**PRE-BID MEETING  
(ADDENDUM NO. I)**

**PROJECT:** H-1685, S-669, W-740--PALMER BLVD., MCGRAFT ST. TO SOUTHERN AVE.

**PROJECT DESCRIPTION:** Milling & Resurfacing with renewal of water, sanitary, and sewer services with some manhole repairs .

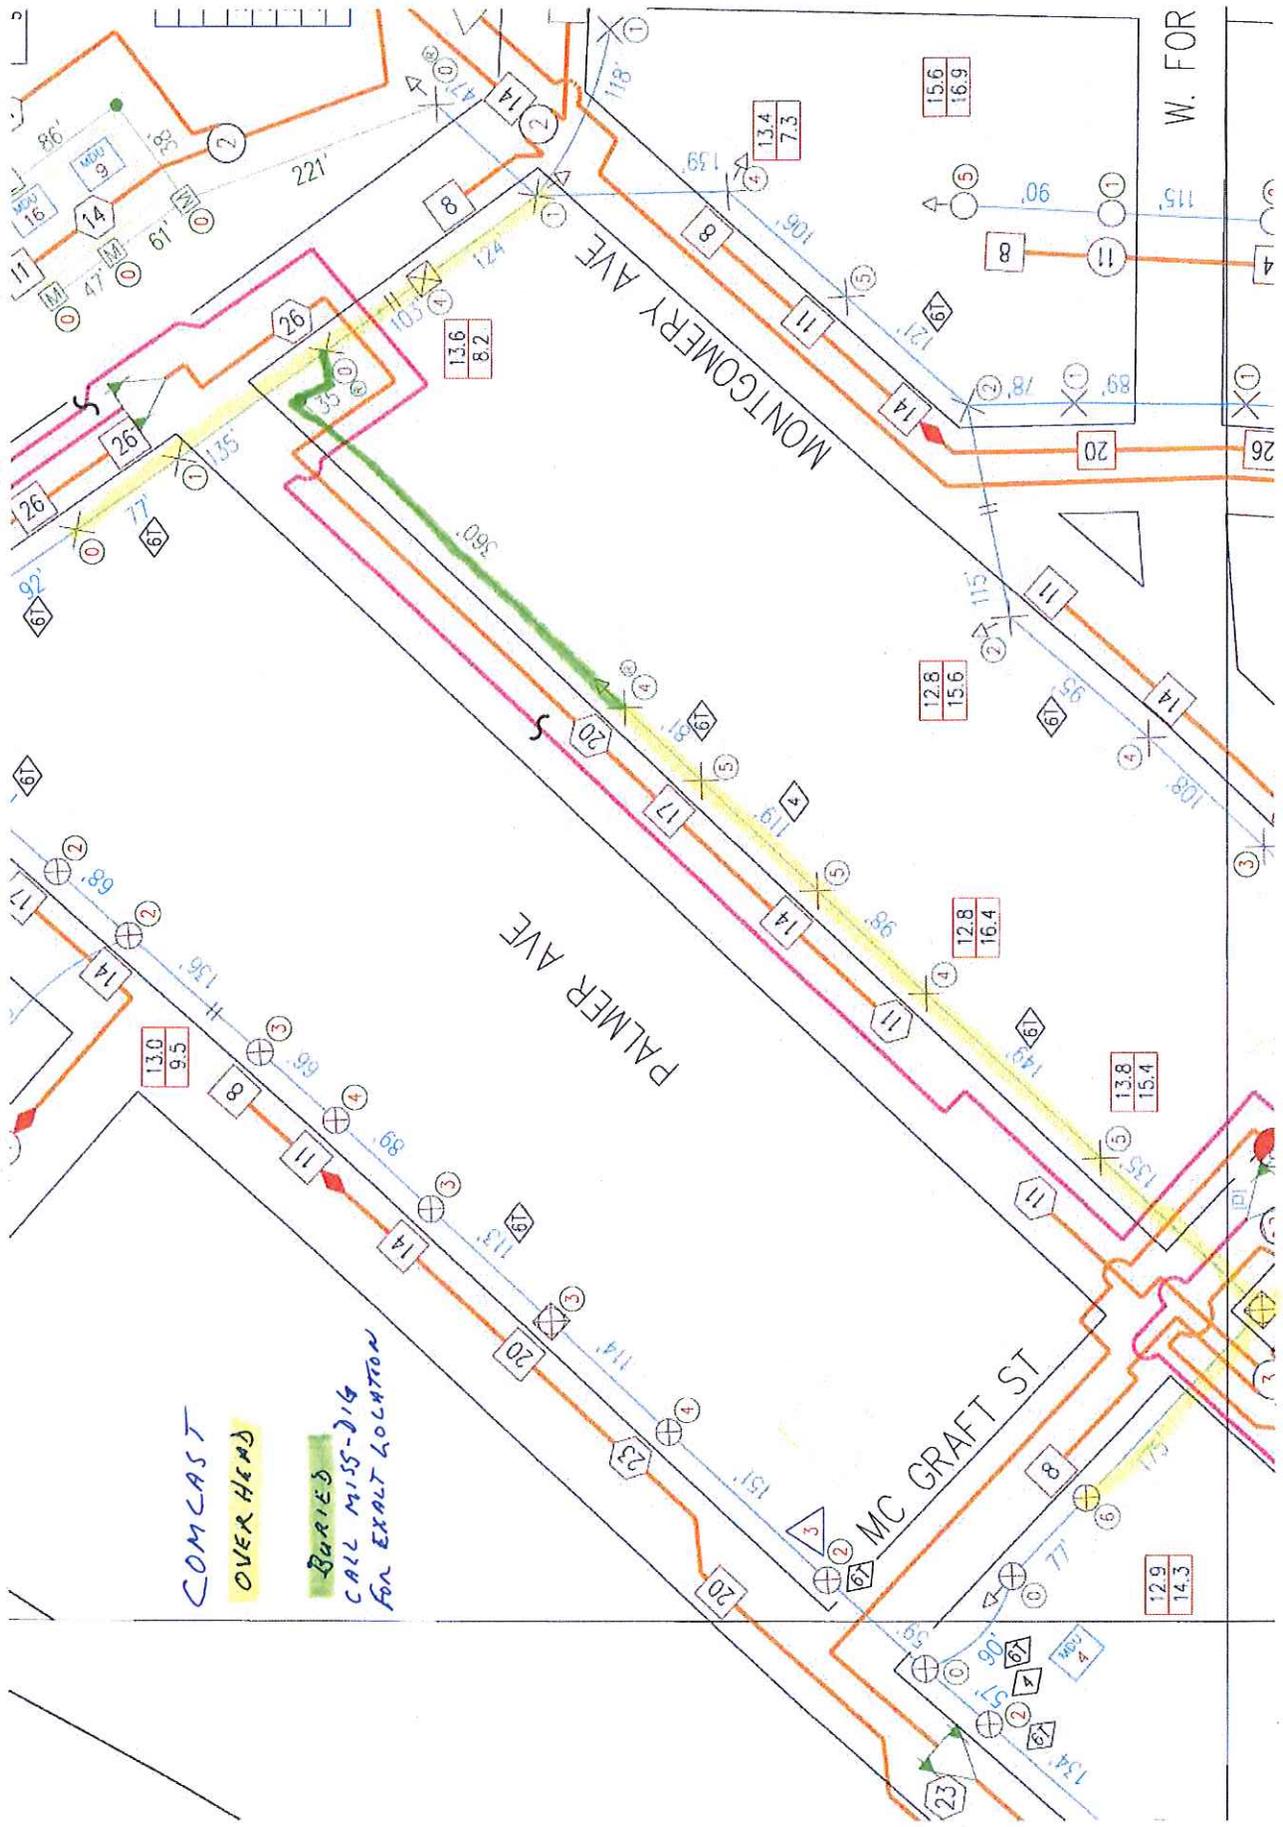
COMCAST  
OVER HEAD

BURIED  
CALL MISS-DIG  
FOR EXACT LOCATION
